Burlington Planning Commission

Burlington Planning Commission Tuesday, July 12, 2016, 6:30-8:30 P.M. Conference Room 12, Ground Floor City Hall, 149 Church Street

TO: JANE KNODELL, COUNCIL PRESIDENT
BURLINGTON CITY COUNCILORS
FROM: BURLINGTON PLANNING COMMISSION
DATE: date
RE: PLANNING COMMISSION TRANSMITTAL OF *ZA-16-14 DOWNTOWN MIXED USE CORE OVERLAY*

Sec. 4.2.2 Downtown and Waterfront Core Official Map Established

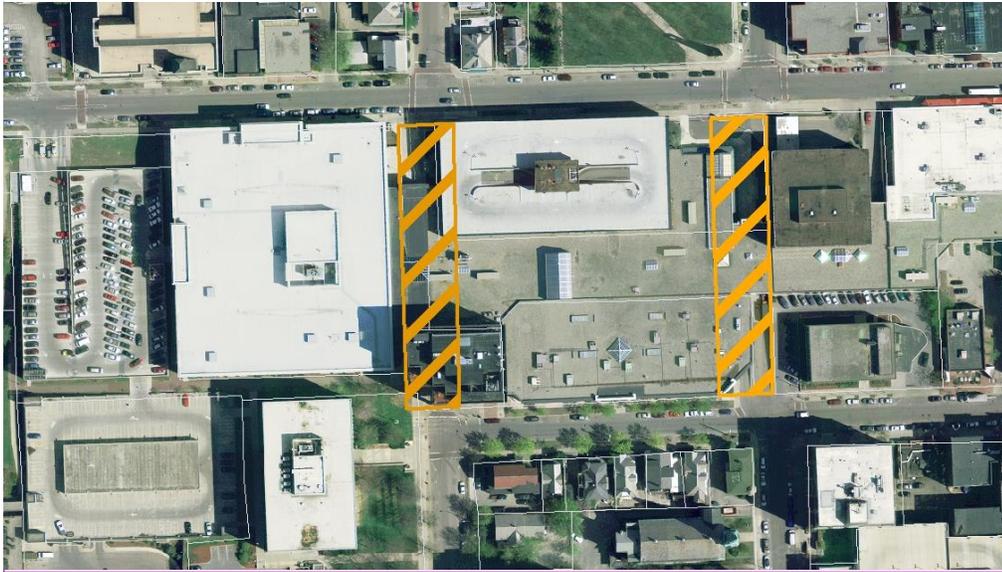
Comment [DEW1]: This will ensure that the proposed north-south connectivity on Pine and St. Paul streets envisioned in planBTV is accomplished. The City will have 120-days to initiate proceedings to acquire any land within this area that may be proposed for new development.

Figure 4.4.1-2 Measuring Height Limits for Church Street Buildings

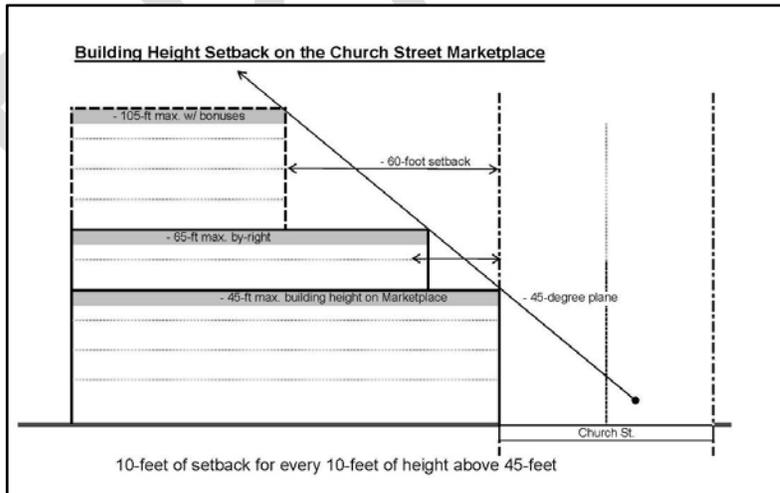
Comment [DEW3]: While outside of the proposed new overlay, this change is already envisioned as part of the currently proposed form-based code to provide better compatibility of building heights on Church Street.

For the purposes protecting the historic character and scale of buildings along the Church Street Marketplace, the maximum height of any building fronting on Church Street shall be limited to ~~38 feet~~ **4-stories not to exceed 45-feet**. Any portion of a building ~~within 100 feet from the centerline of Church Street exceeding 45-feet~~ shall be set-back a minimum of ~~16~~ **10**-feet for every 10-feet of additional building height above ~~38~~ **45**-feet.
